SERVICE BULLETIN

ENGINE - DIFFUSER AND COMBUSTION GROUP AND STAGE 1 TURBINE NOZZLE ASSEMBLY - INTRODUCE THERMAL BARRIER COASTING ON INNER AND OUTER COMBUSTION CHAMBER LINERS - CATEGORY CODE 5 - MOD.ENG-72-0060

Location of Outer Combustion Chamber Liner Segments Fig.1

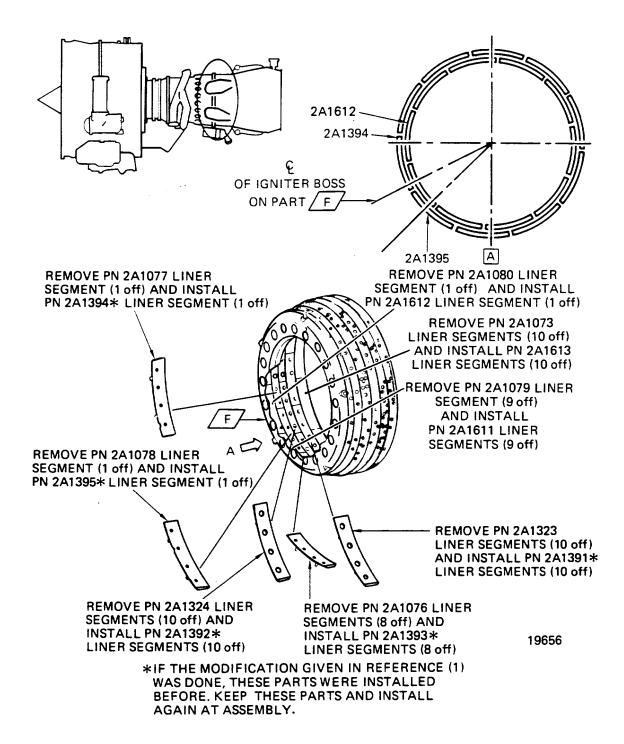
(1) Install the Outer Combustion Chamber Liner Segments 2A1391 (10 off), 2A1392 (10 off), 2A1393 (8 off), 2A1394 (1 off), 2A1395 (1 off), 2A1611 (9 off), 2A1612 (1 off) and 2A1613 (10 off) as necessary by the approved procedure in Reference (2), Chapter/Section 72-42-60, Assembly. See Figure 1.

NOTE: For Outer Combustion Chamber Liners which have the modification given in Reference (1), coated segments (which were remove and kept) will be installed again at the applicable locations.

Location of Inner Combustion Chamber Liner Segments Fig.2

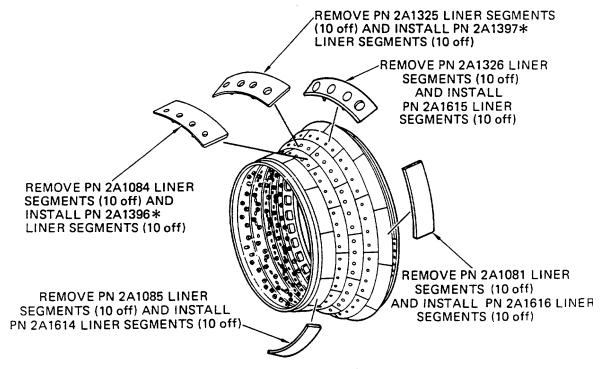
(2) Install the Inner Combustion Chamber Liner Segments 2A1396 (10 off). 2A1397 (10 off), 2A1614 (10 off), 2A1615 (10 off), and 2A1616 (10 off) as necessary by the approved procedure in Reference (2), Chapter/Section 72-44-30, Assembly. See Figure 2.

NOTE: For Inner Combustion Chamber Liners which have the modification given in Reference (1), coated segments (which were remove and kept) will be installed again at the applicable locations.
